ADDENDUM NO. 1  
TO THE CONTRACT DOCUMENTS  
For the Construction of  
City of Concord Monument Signs (Qty 2)  
City of Concord  
850 Warren C. Coleman Boulevard  
Concord, NC 28206

LANDSCAPING PLAN AND PLANTING SCHEDULE

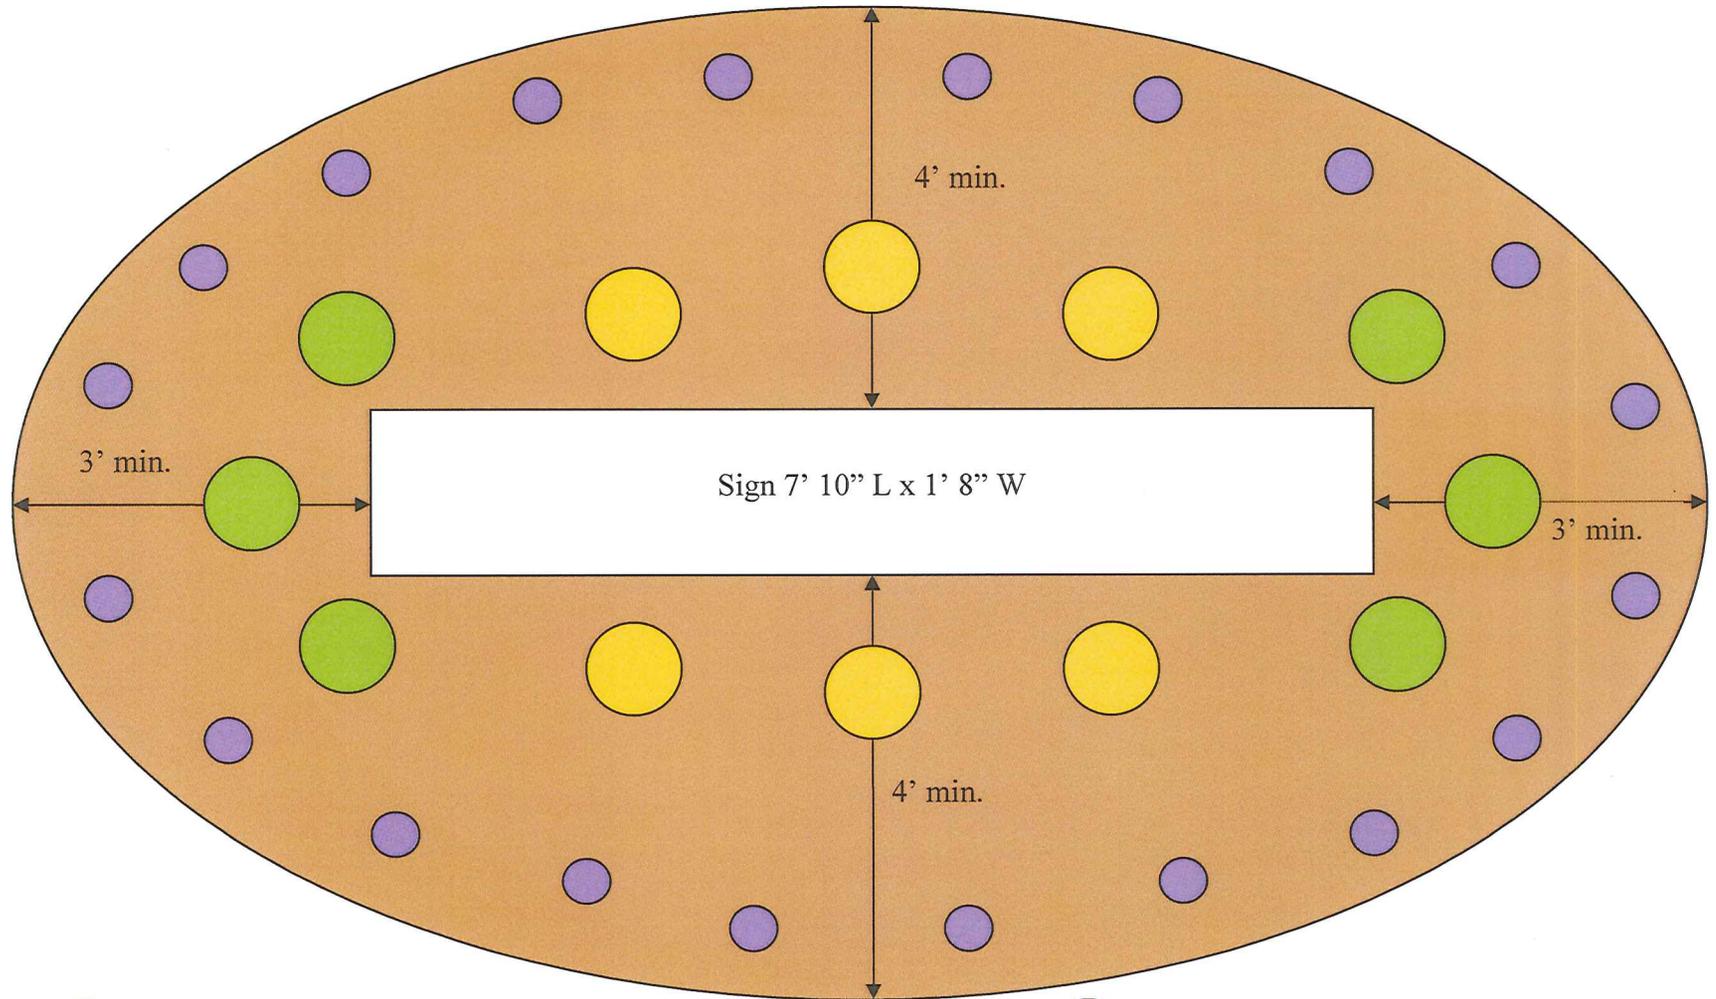
3. Landscaping Plan – The landscaping plan was previously and inadvertently excluded from the bid documents and is now provided on the attached sheet. Please include pricing for the same landscaping at each of the two signs.
